*Title:* Technical Review of Selected Reports on Performance Contracting, Inc. Sure-Flow Strainer™ Test Data

# **Technical Review of Selected Reports on Performance Contracting, Inc. Sure-Flow Strainer™ Test Data**

**April 27, 2000**

**Robert Elliott  
Office of Nuclear Reactor Regulation  
Nuclear Regulatory Commission  
Rockville, Maryland**

Fig. 1. Clean-Strainer Head-Loss for Various BWROG Strainer Designs [Ref. 3].

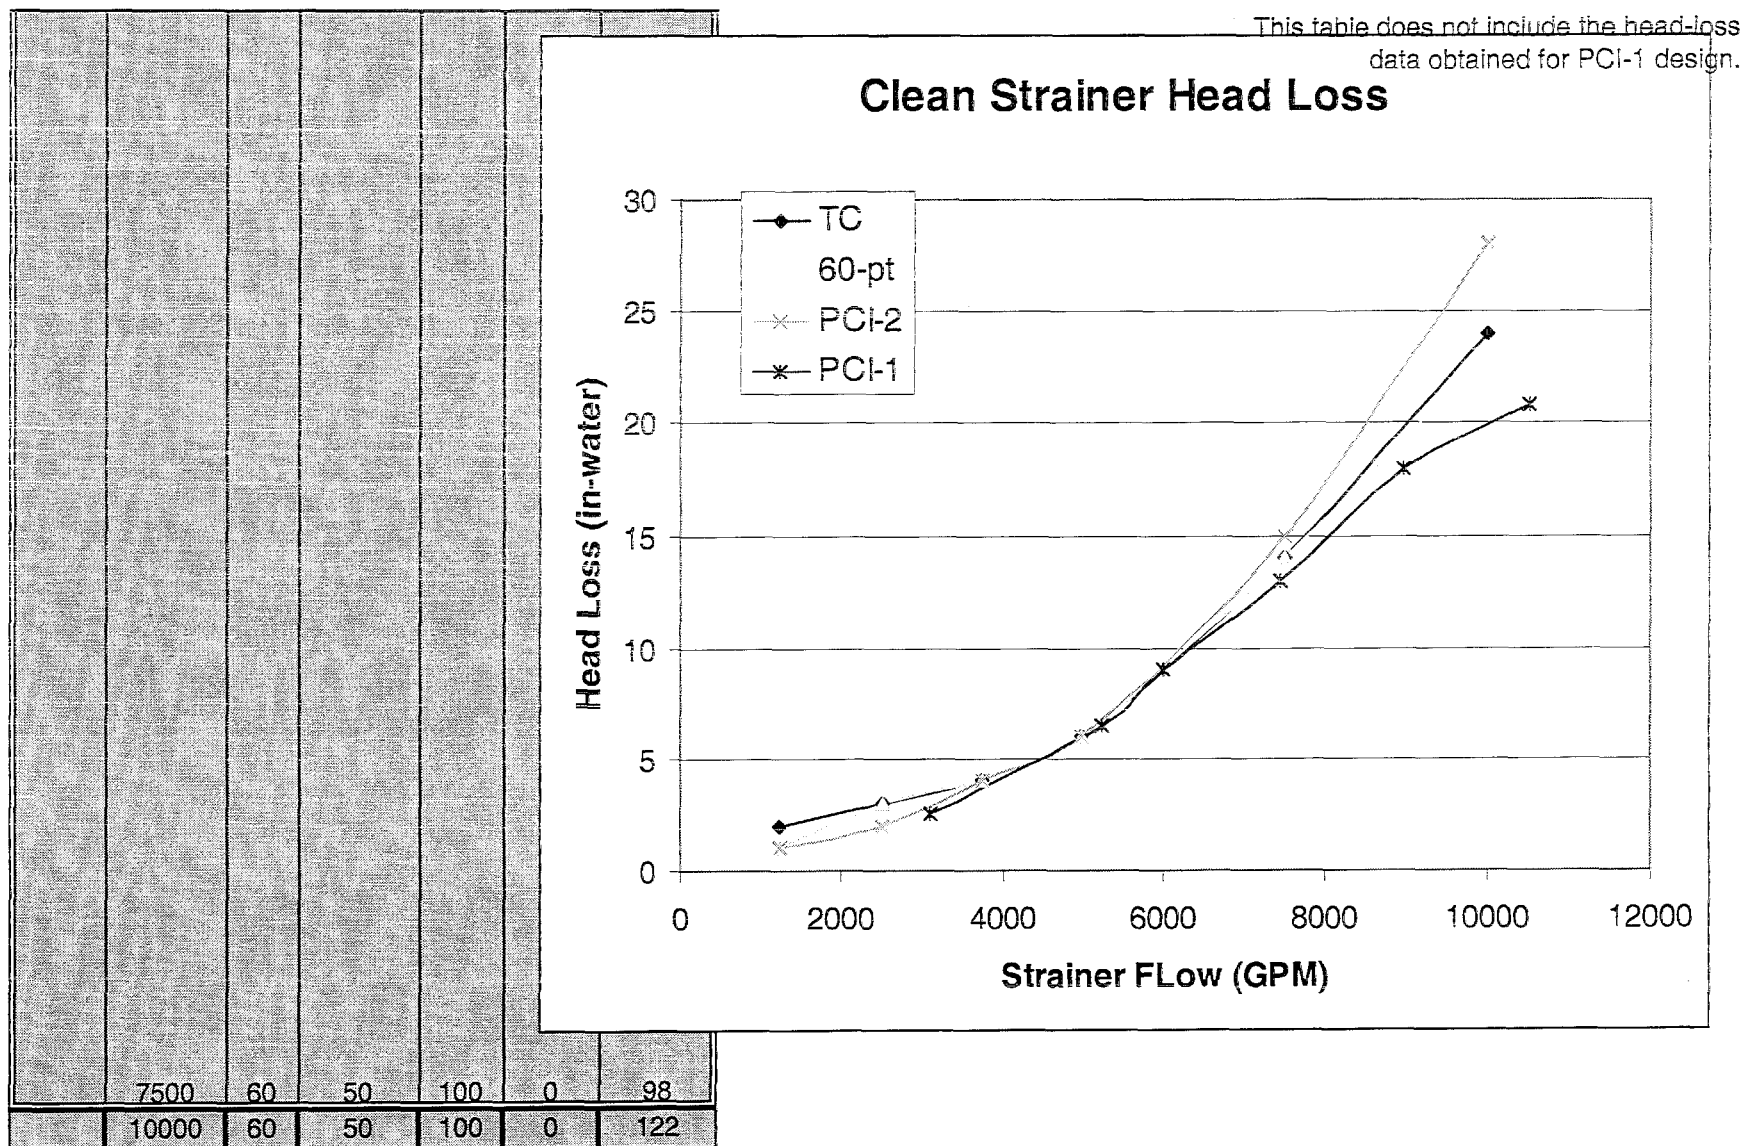
The clean-strainer head-loss data were obtained at two different facilities: (1) the Electric Power Research Institute (EPRI) facility used in the BWROG testing [Ref. 3] and (2) Fairbanks Morse Pump Company [Ref. 5]. These data are plotted in Fig. 1 along with the clean-strainer head-loss data for other strainer models examined by the BWROG (e.g., the 60-point strainer and the truncated cone). As evident from Fig. 1, the truncated cone and the advanced designs resulted in about the same clean-strainer head loss.

The clean-strainer head loss plotted in Fig. 1 includes the acceleration head-loss component, and the connecting flange head loss. PCI developed an empirical correlation for the strainer head loss by itself as follows.

This correlation appears to perform well and, in fact, is comparable in head-loss prediction to the head-loss values used in the Dresden strainer head-loss analyses.

Fig. 3. Point-By-Point Comparison of Model Predictions with Test Data.

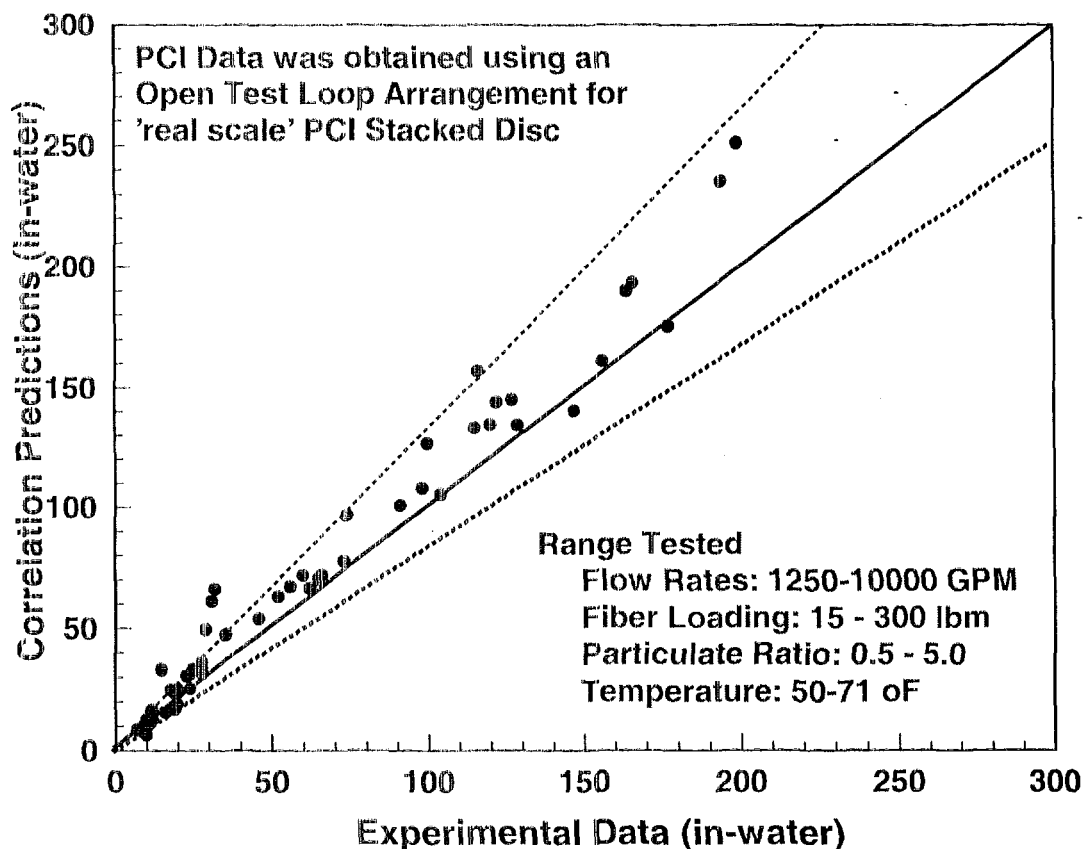
Although these equations appear complex, they can be solved easily. The results of the comparison are presented in Figs. 3 and 4. As shown in these figures, the NUREG/CR-6224 correlation can predict the head-loss data for PCI strainers fairly accurately (within  $\pm 25\%$ )..

Figure 3 presents a point-by-point comparison of NUREG/CR-6224 model predictions with the experimental data. All the points were within  $\pm 25\%$  bounds, indicating good agreement between the correlation and the test data. This agreement confirms that the head loss caused by deposition of debris on stacked-disk strainers can be simulated adequately by accurately accounting for the change in the flow cross section. This comparison also suggests that the PCI approach is probably accurate, although we cannot make such a positive conclusion until we examine how the approach was implemented in the HLOSS computer code.

Fig. 4. Change in Effective Strainer Surface Area as a function of the Volume of Debris Deposited.

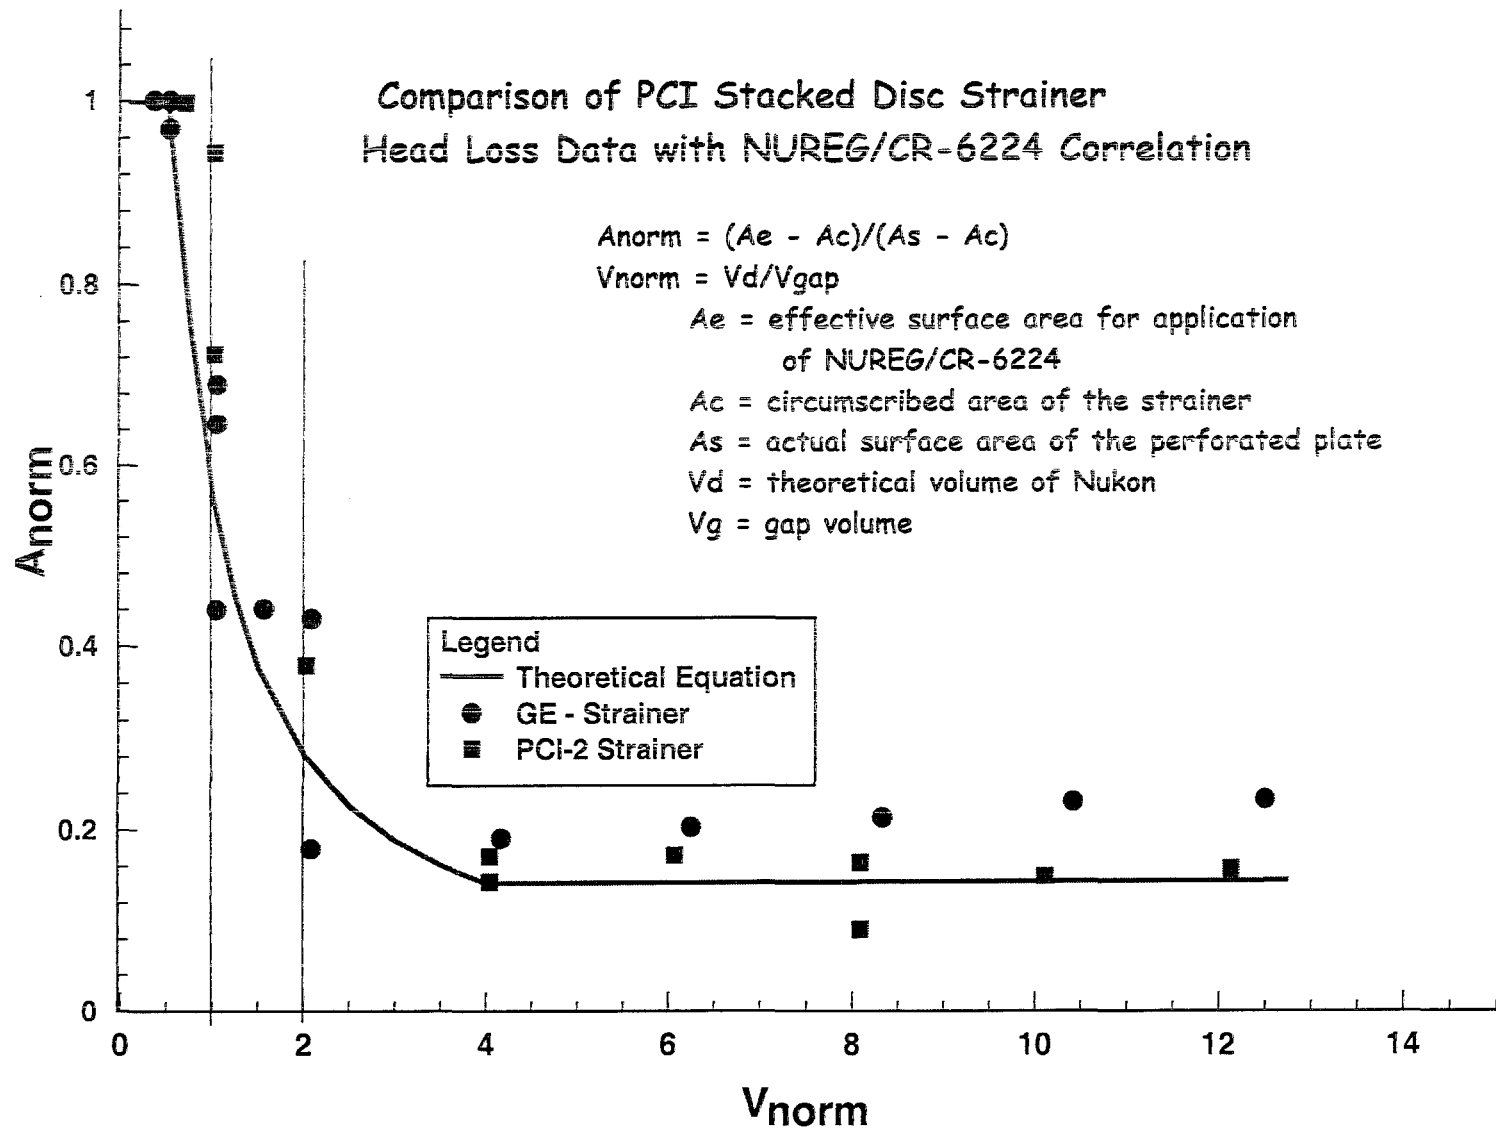
Figure 4 presents a plot of effective strainer area as a function of the volume of debris being deposited. This curve can be used to input the strainer area into the BLOCKAGE computer code.
